Incorrect Starter Mounting Bolts

BULLETIN

Models Affected: 2009-2011 Model Year Vision with GM 8.1 L Propane Engines

S10SK

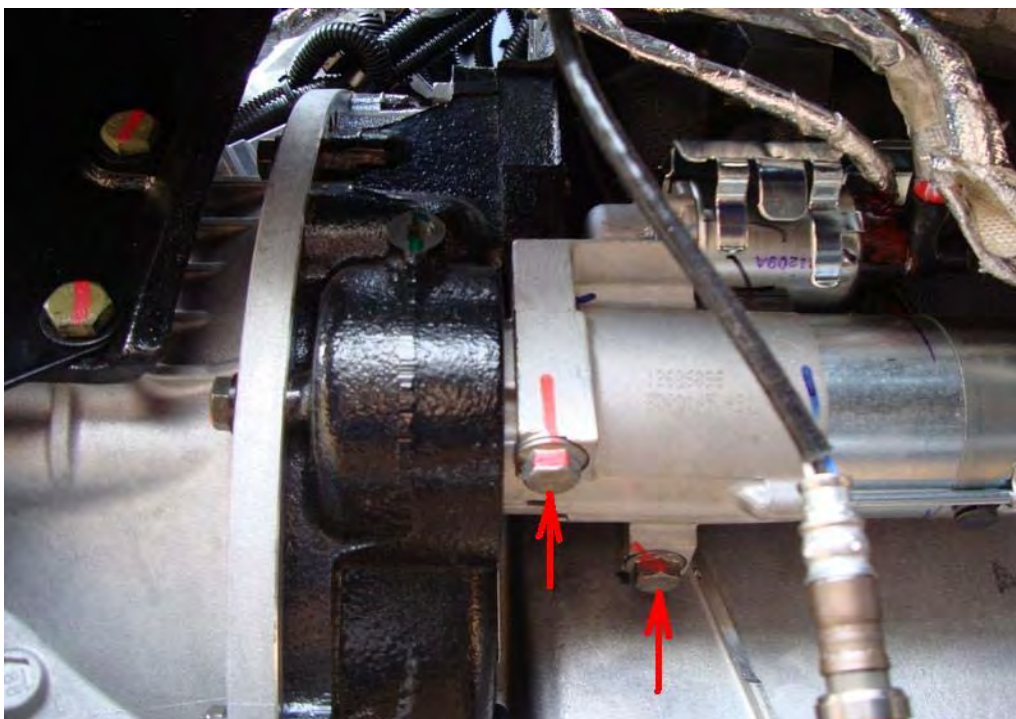
The flange on the starter mounting bolts is too large and prevents the bolt from seating properly. If the bolt does not seat properly it may become loose and cause starting problems.

Replace original starter mounting bolts with new mounting bolts with proper size flange.

3. Replace starter mounting bolts one at a time (so you don't have to remove the starter) with the new bolts (10003378). **Do NOT use any washers.** Torque: 37 FT-LB
4. Remove wheel chocks and place bus back in normal service.
